RESPONSE TO REQUEST FOR ADDITIONAL INFORMATION

US-APWR Design Certification

Mitsubishi Heavy Industries

RAI NO.: NO. 1055-7184 REVISION 0
SRP SECTION: 09.01.02 - New and Spent Fuel Storage
APPLICATION SECTION: 1.9,3.8,5.1,9.1,12.3
DATE OF RAI ISSUE: 10/07/2013

Figure 09.01.02-59.1 Analysis model for abnormal fuel location in the racks

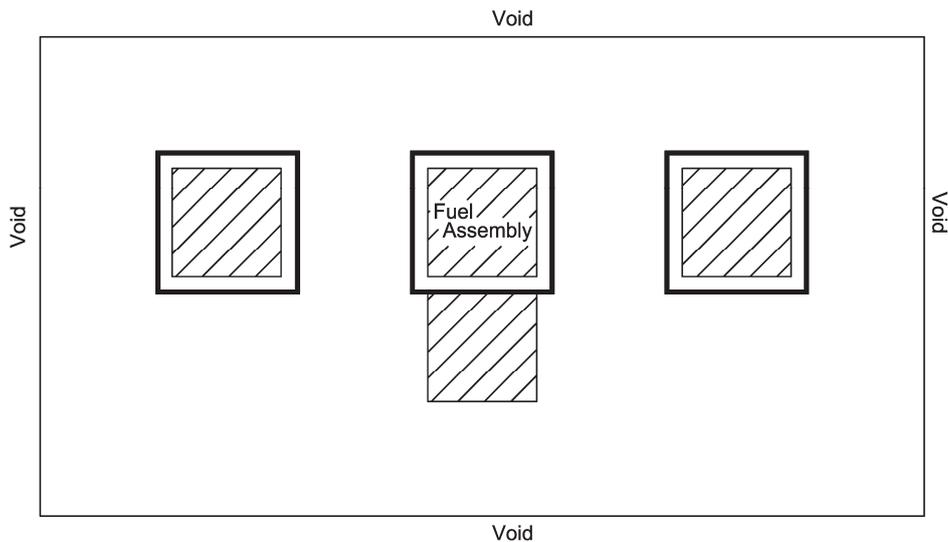
Please revise and update Technical Report MUAP-13011-P to describe the limiting arrangement of fuel used for performing the analysis for ensuring reactivity controls are maintained consistent with 10 CFR 50.68(b)(4) when analyzing for a dropped fuel bundle with fuel in the containment racks, or provide the specific alternative approaches used and the associated justification.

The analysis result of the limiting case of abnormal fuel location in the racks is summarized in Table 2-7 of Technical Report MUAP-13011-P (R0) "Criticality Analysis for US-APWR Containment Racks." The corresponding analysis model is shown in Figure 09.01.02-59.1. This case assumes mislocation of a fuel assembly. The fuel assembly is never mislocated between cells, since the separation between cells is narrower than the width of an assembly. The case of a drop accident does not result in an increase in reactivity, and therefore it is not considered.

Technical Report MUAP-13011 will be revised to include this figure of the analysis model.

Figure 1 – FRS for Containment Rack (NS Direction)

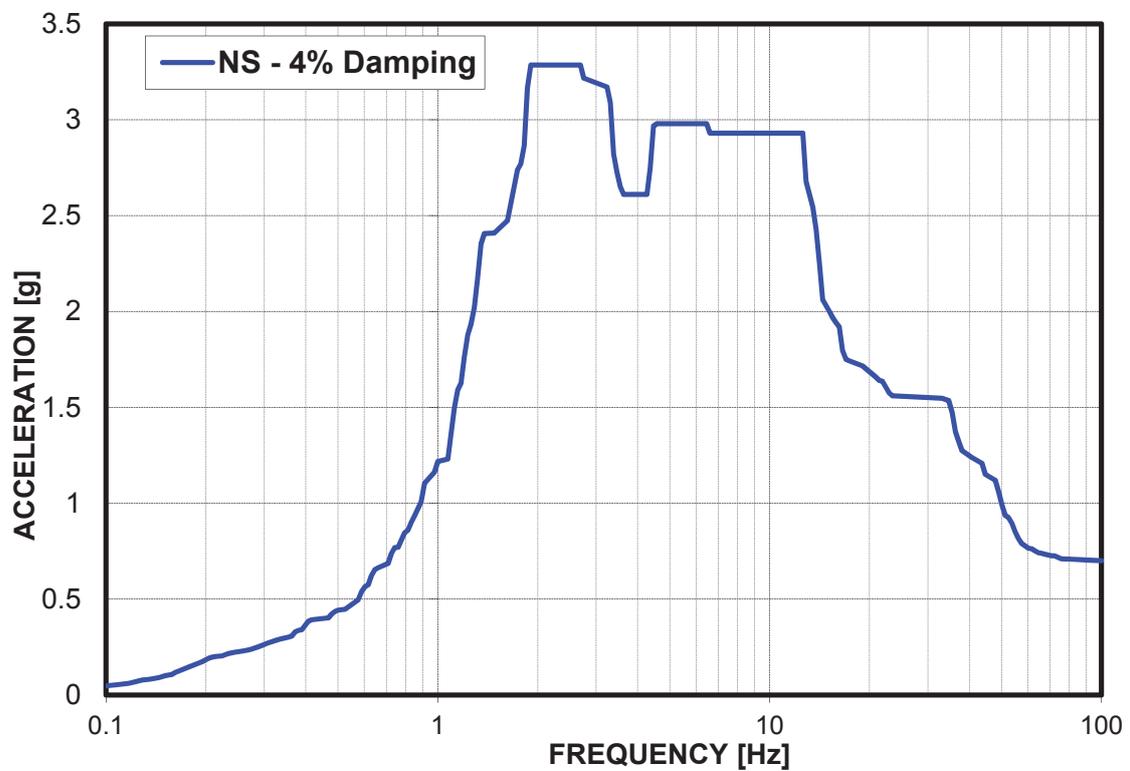
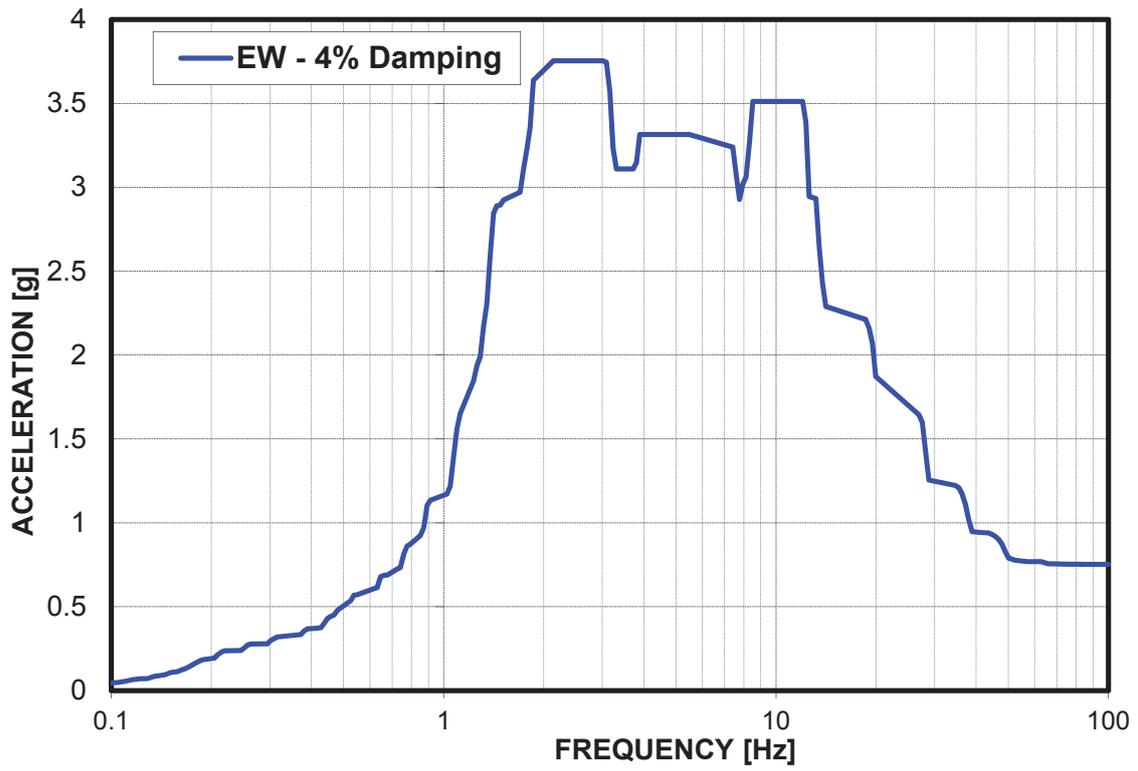
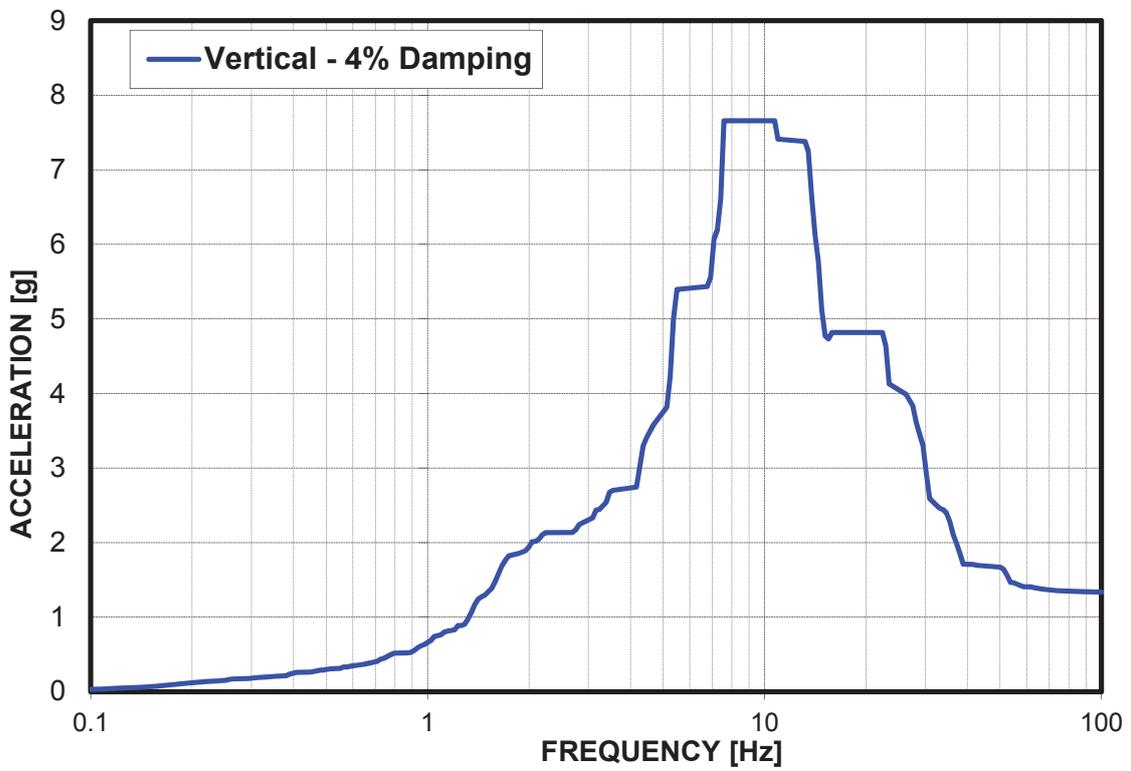
1. Provide the amount of fluid mass that was included in the frequency calculation.
2. The fluid mass represents only the impulsive part of liquid motion against the rack during earthquakes. Was the liquid sloshing motion against the rack considered in the analysis?
3. Provide the water depth and the dimensions of the refueling cavity.
4. The lower natural frequency may not result in larger corresponding acceleration. It depends on the shape of floor response spectra. Provide information for the floor response spectra used and the natural frequencies with and without the fluid for the rack.

3. The water depth of the refueling cavity in the containment rack area during fuel assembly transport is controlled to be in the range from 45'-1" to 45'-7". The dimensions of the refueling cavity are shown in MUAP-13012-P (R0) Figures 1-1 and 1-2 (Pages 26 and 27).
4. The floor response spectra (FRS) are shown in Figures 1 through 3. In addition, the natural frequency in horizontal direction with fluid for the rack (including only inside the containment rack) is 58 Hz and the natural frequency in horizontal direction without the fluid for the rack is 81 Hz.

Figure1 Outline drawing of mounting angle and rigger plate

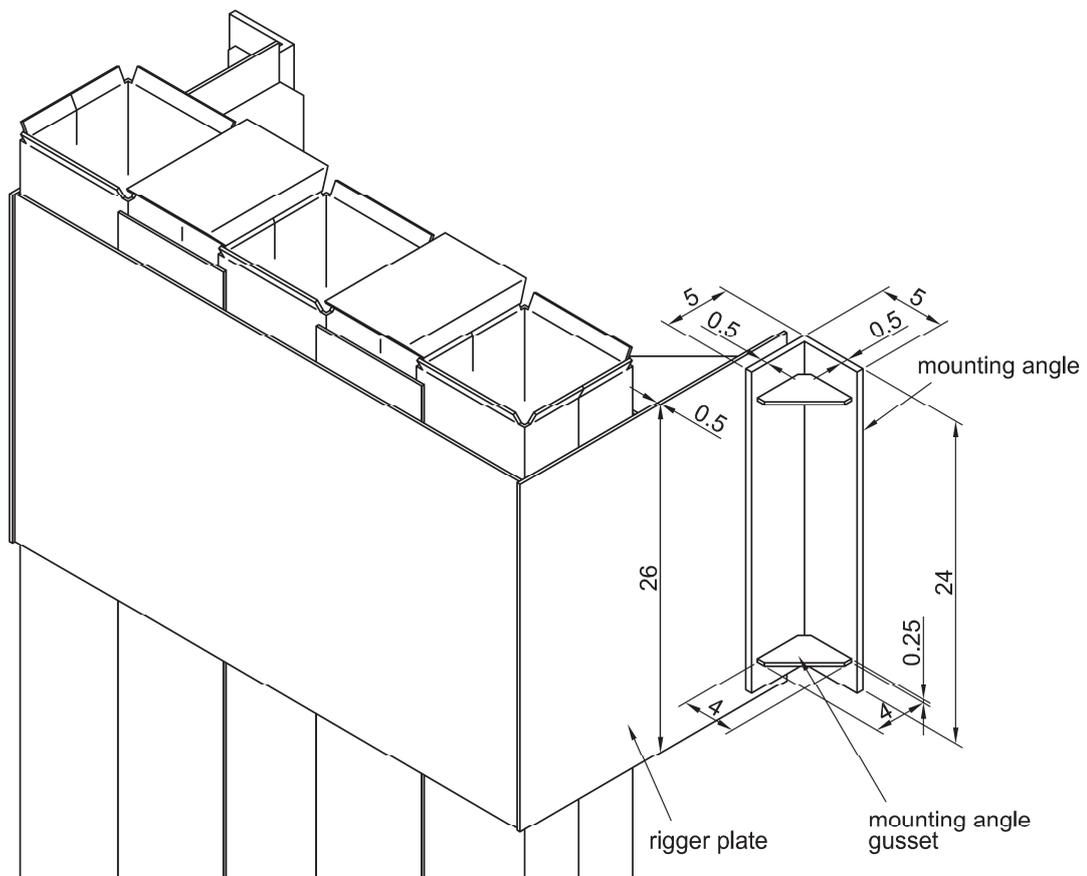
The size and dimensions of the mounting angle and rigger plates are not given in Figure 2-1 or in Tables 3-5 and 3-6. The applicant is requested to provide this information. The above information should be included in the applicable portion of the technical report.

The size and dimensions of the mounting angle and rigger plates are shown in Figure 1 and provided below.

Rigger Plate Width	26 in
Rigger Plate Thickness	0.5 in
Mounting Angle Depth	24 in
Mounting Angle Width	5 in
Mounting Angle Thickness	0.5 in
Mounting Angle Gusset Width	4 in
Mounting Angle Gusset Thickness	0.25 in

Figure 1 Sketch showing mathematical model

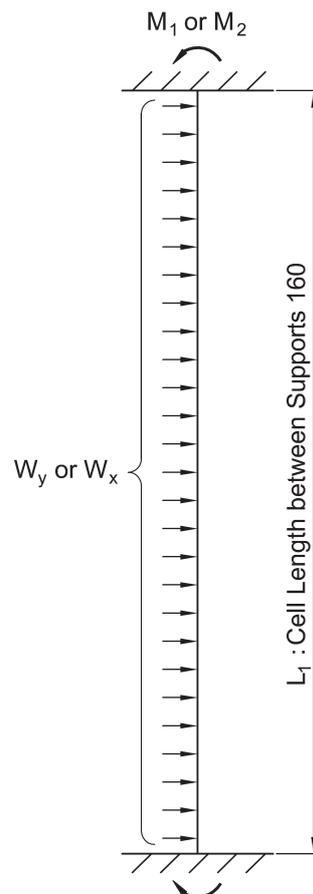
1. Describe how M1 and M2 are calculated.
2. Provide dimensions/sketches of the cross section of the fuel cell.
3. Why are Z1 and Z2 the moduli of the rack and not moduli of the fuel cell since the calculation pertains to the fuel cell?

1. The method of calculating M₁ and M₂ is provided below. The mathematical model is shown in Figure 1.
2. The dimensions/sketches of cross section of the fuel cell will be provided in Figure 2.
3. In Section 3.7.2.1, "Fuel Cell", the bending stress considering rack cell and rack filler panel are evaluated (as shown in Figure 2).

Figure 1 Sketch showing dimensions

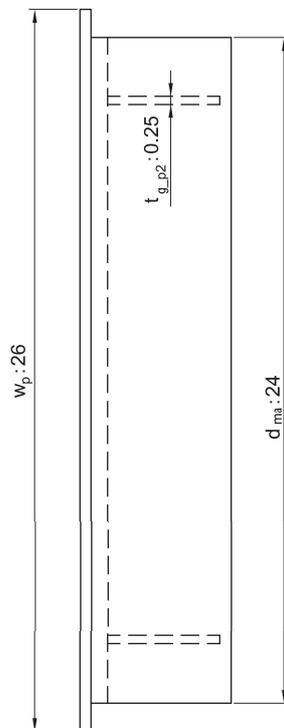
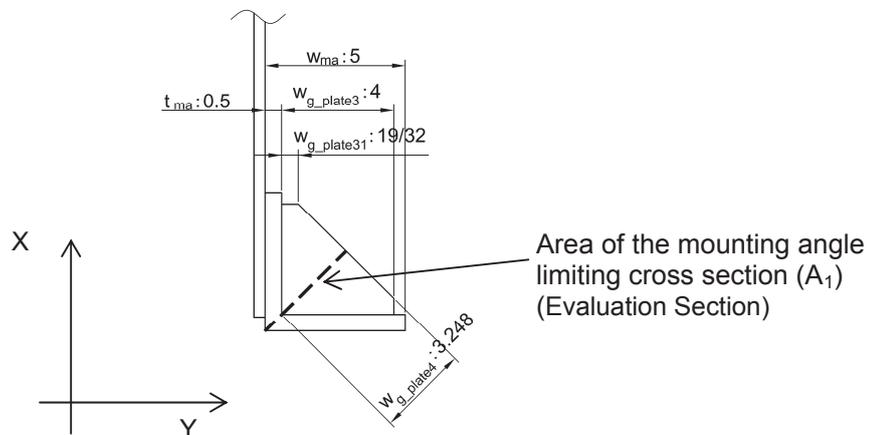
1. Provide details/sketches to show how these quantities are calculated.
2. Both Z4 in Section 3.7.2.2 and Z2 in Subsection 3.7.2.1 represent the Y-axis section modulus of the rack. Why Z4 has a value of 44.31 in³, which is different from Z2 that has a value of 95.95 in³?

Figure 1 A sketch showing the shear stress

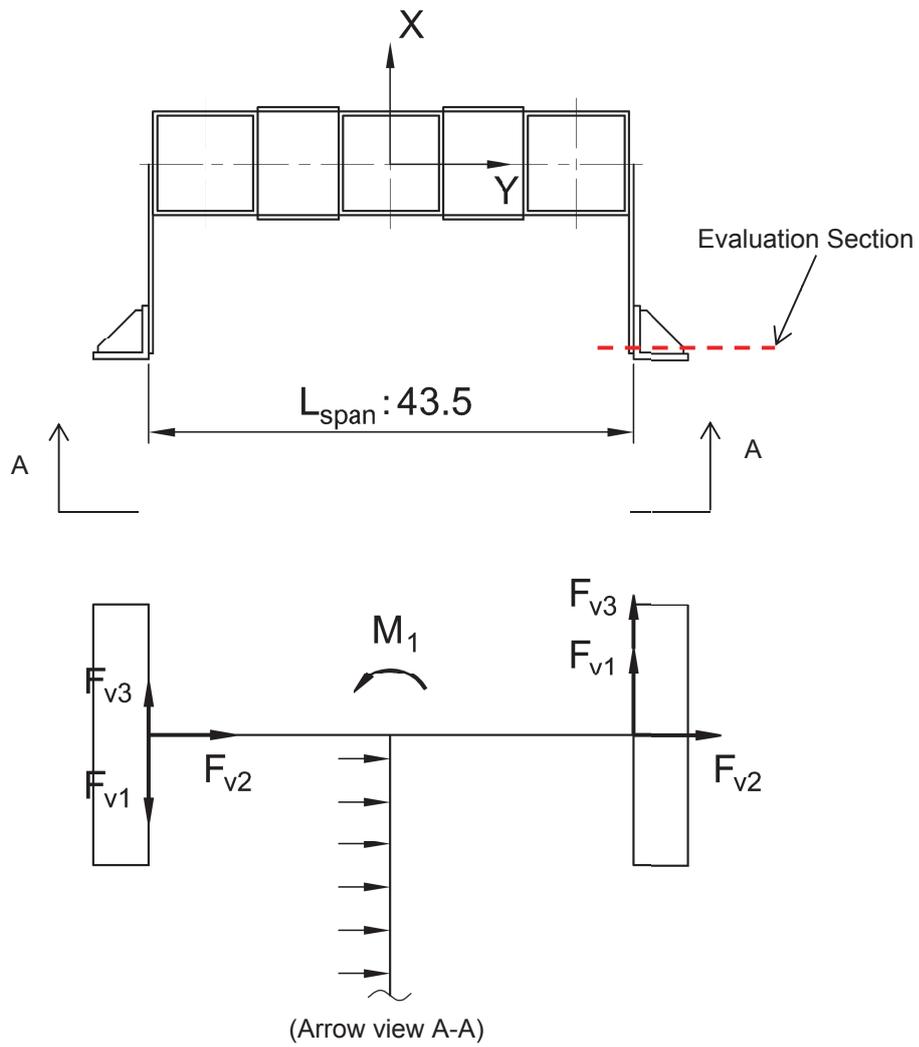
The applicant is requested to provide a sketch that shows how the resulting shear was formed for the CR and how the resisting shear was provided by the mounting angle. The requested information should be included in the RAI response.

The sketch that provides how the shear was formed for the CR is shown in Figure 1.

The methodology for calculating the resulting shear (W_3) at evaluation section (shown in Figure 1) is provided below. Additionally, the resisting shear (F_{V1}) by a force couple is provided below.

Figure 1 Sketch showing Mounting Angle-to-Wall Welds

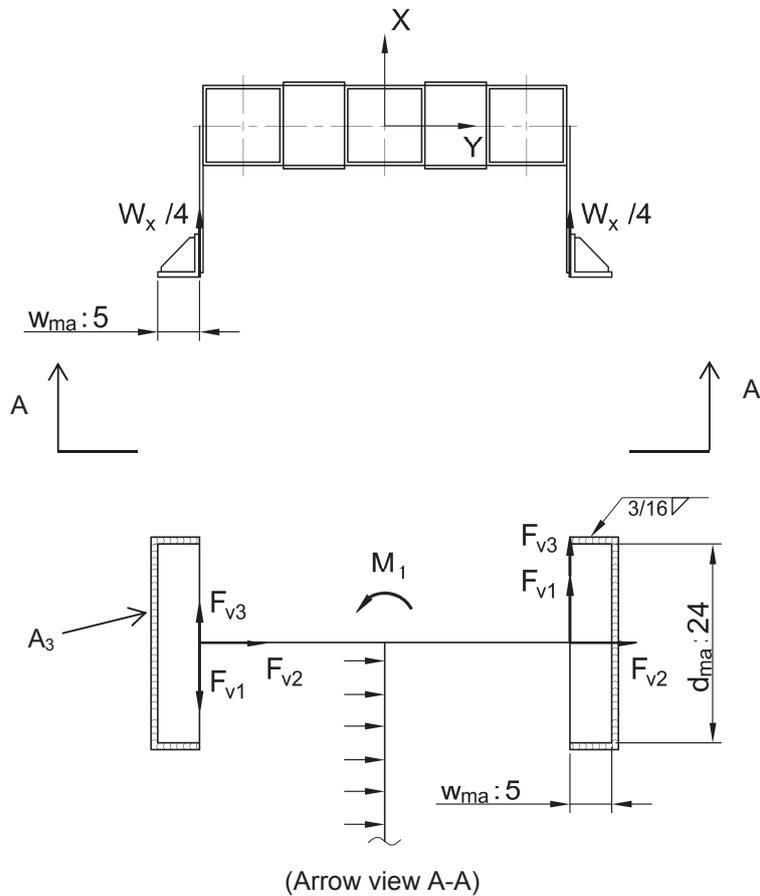
The applicant is requested to provide details/sketches as to how W₄ and A₃ are calculated and the type of weld material used in fillet weld. The requested information should be included in the RAI response.

A sketch is shown in Figure 1 and the answers to the W₄ and A₃ are provided as follows.
The material corresponding to SA240 will be used as the welding material.

Figure 1 Sketch of tension caused by Uplift Force

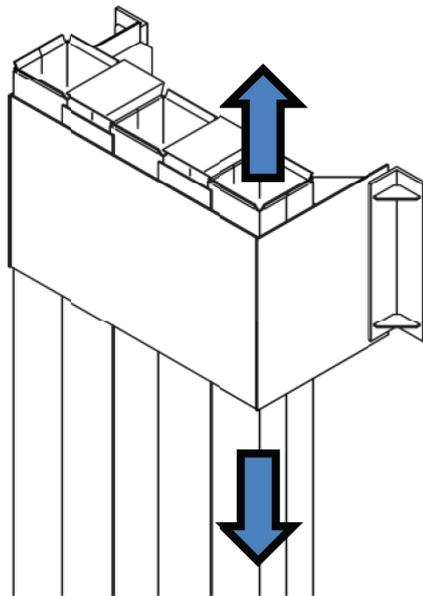
1. A description of the mathematical model and assumptions used in this analysis.
2. How is the 4,400 lbf uplift force determined to be enough to uplift the stuck fuel?
3. The location of the maximum stress of 1,197 psi. Does the location of the maximum stress depend on the assumption of how the fuel assembly gets stuck?
4. Are the mounting angles and welds adequate for the 4,400 lbf uplifting force?
5. What is the maximum stress developed in the fuel assembly? The applicant is requested to show that the integrity of the fuel assembly is maintained.

1. The stuck fuel event is analyzed by manual calculations using strength of materials formula. Specifically, the following scenarios are analyzed:
 - a. The entire 4,400 lbf uplift force is resisted by a single storage cell through direct tension (only 50% of cell area is credited, shown in Figure 1).

Figure 2-4 MCNP Model for Fuel Displacement within Cells of CR

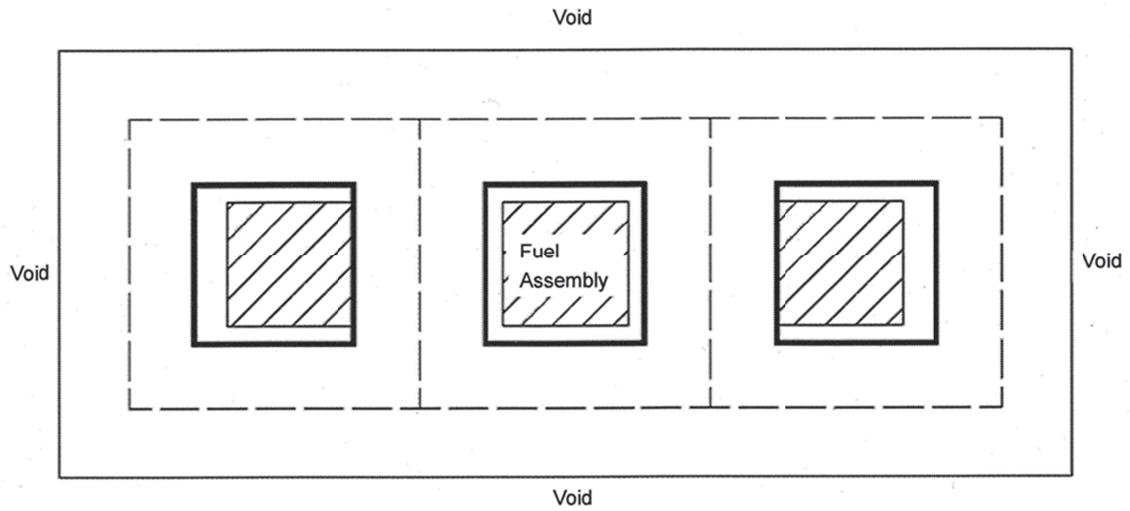
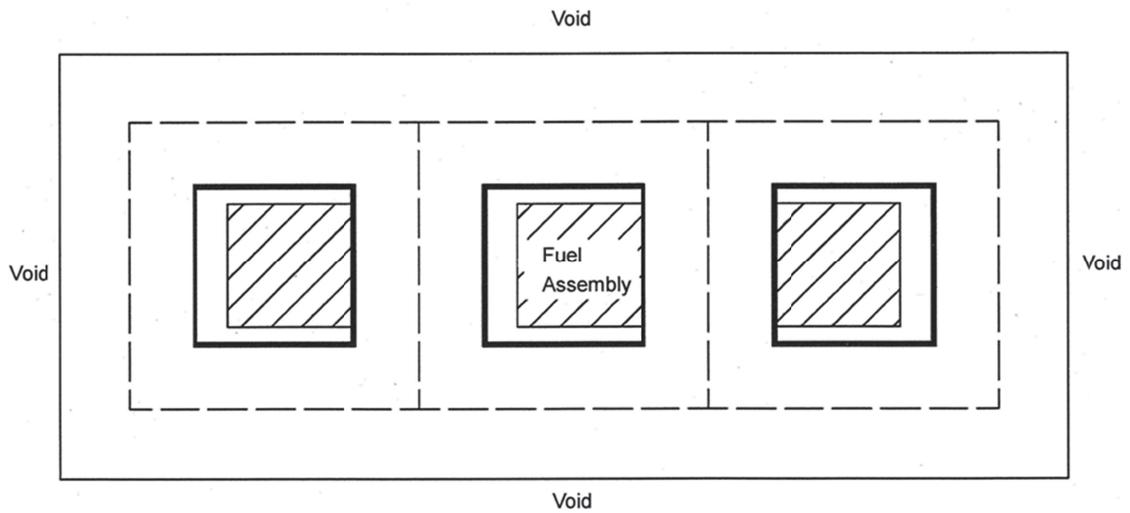
(Question 09.01.02-59)

(Question 09.01.02-59)
Add Figure 2-5 based on Figure 09.01.02-59.1.
